ADDENDUM NO. 1

LUCCHESI TURF FIELD REPLACEMENT PROJECT City Project Number C14502008

March 8, 2023

DRAWN BY: **KL** CHECKED BY: **WD/DC**
 DATE ISSUED: **02/17/23** SCALE: **1"=20'-0"**
 PROJ. NO.: **2108300**
 SHEET NO.: **L6.0**

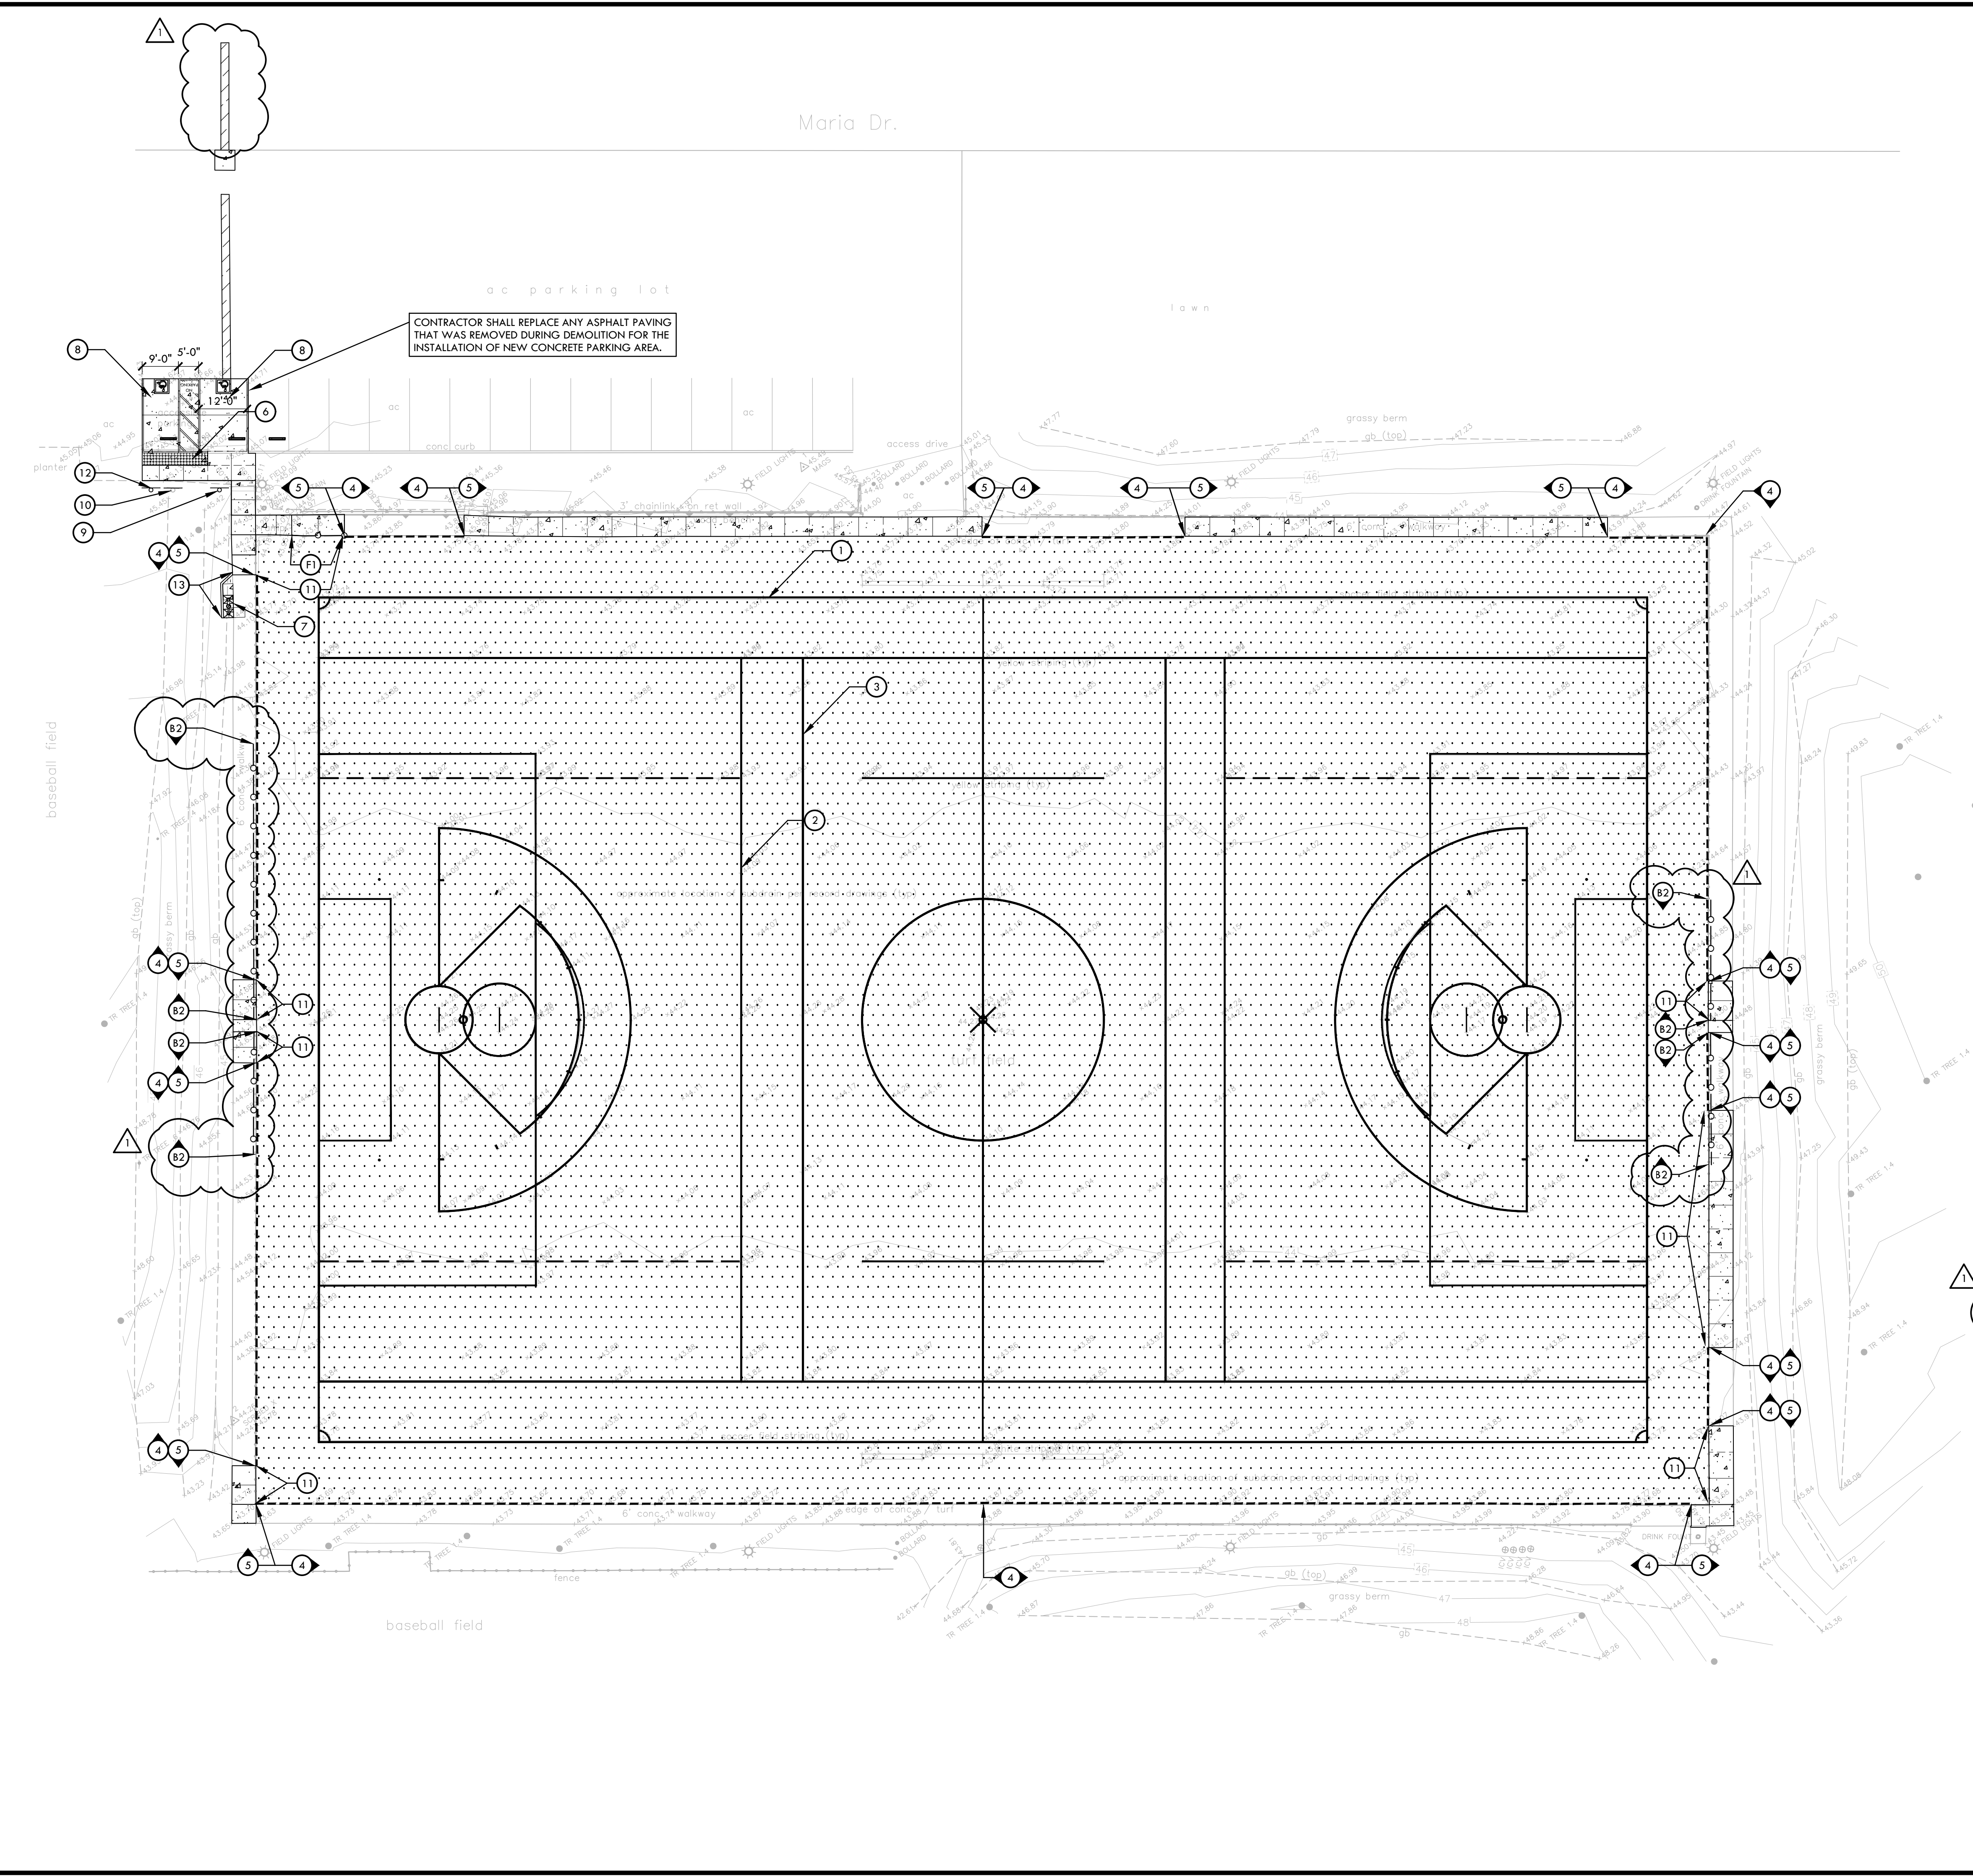
4. Drawing Sheet L6.0 was **revised** and **posted** in the City website.
Revised L6.0 shall be incorporated in the bid documents. Revisions include modification to the limits of new asphalt paving in Maria Dr and updated limits to Bid Alternate #2 – Fence Fabric Replacement.
